<b>Well Name:</b> MR POTATO HEAD 11-14 FED COM	<b>Well Location:</b> T24S / R29E / SEC 11 / NWE / 32.2378696 / -103.9511783	<b>County or Parish/State:</b> EDDY / NM
<b>Well Number:</b> 236H	<b>Type of Well:</b> OIL WELL	<b>Allottee or Tribe Name:</b>
<b>Lease Number:</b> NMNM088134	<b>Unit or CA Name:</b>	<b>Unit or CA Number:</b>
<b>US Well Number:</b> 3001553340	<b>Operator:</b> DEVON ENERGY PRODUCTION COMPANY LP

Notice of Intent

**Sundry ID:** 2784577

<b>Type of Submission:</b> Notice of Intent	<b>Type of Action:</b> APD Change
<b>Date Sundry Submitted:</b> 04/11/2024	<b>Time Sundry Submitted:</b> 11:02
<b>Date proposed operation will begin:</b> 04/11/2024

MR POTATO HEAD 11-14 FED COM 236H

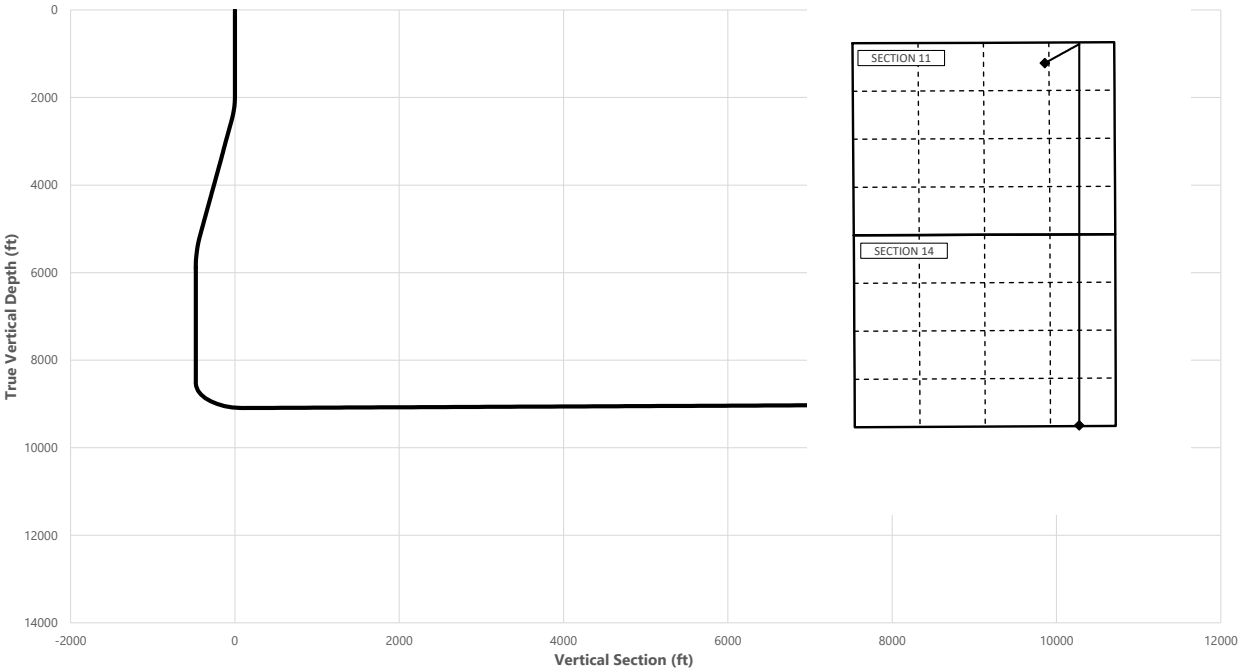
**Procedure Description:** Devon Energy Production Co., L.P. (Devon) respectfully requests to move the BHL on the subject well. Please see attached revised C102, drill plan (break test & offline cement variance included), and directional plan. Permitted BHL: SESE 20 FSL, 540 FEL, 14-24S-29E Proposed BHL: SESE 20 FSL, 740 FEL, 14-24S-29E No new leases have been added since approved APD.

Well: MR POTATO HEAD 11-14 FED COM 236H  
County: Eddy  
Wellbore: Permit Plan  
Design: Permit Plan #1

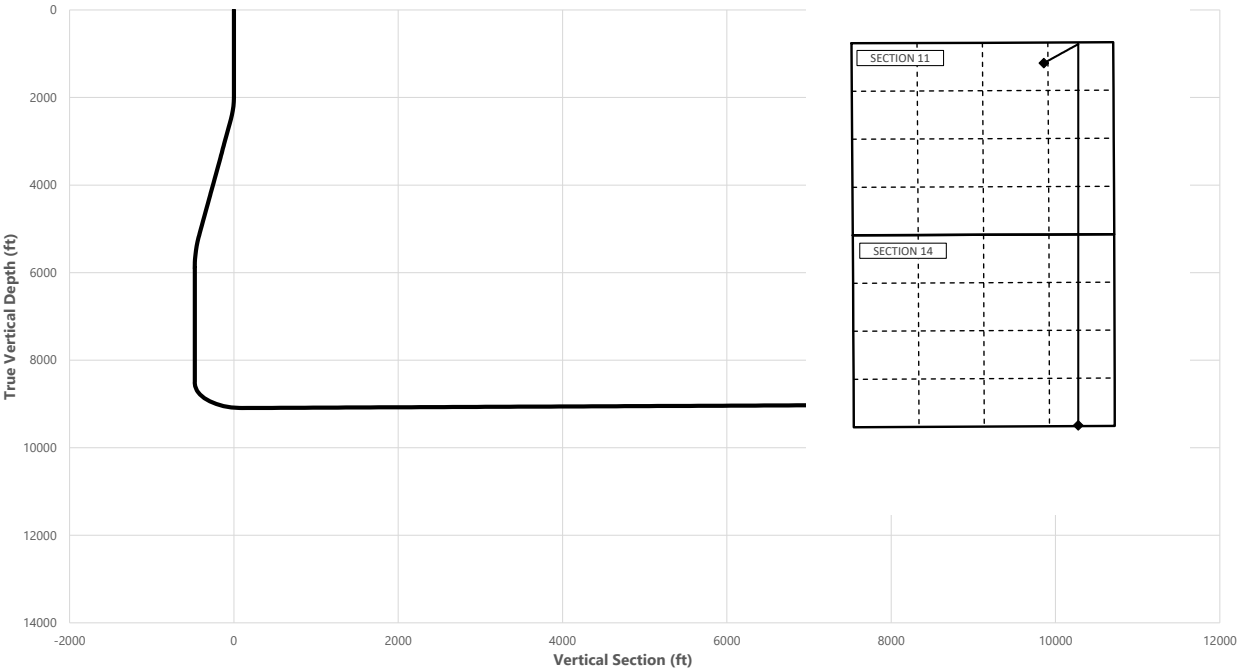
**Procedure Description:** Devon Energy Production Co., L.P. (Devon) respectfully requests to move the BHL on the subject well. Please see attached revised C102, drill plan (break test & offline cement variance included), and directional plan. Permitted BHL: SESE 20 FSL, 540 FEL, 14-24S-29E Proposed BHL: SESE 20 FSL, 740 FEL, 14-24S-29E No new leases have been added since approved APD.
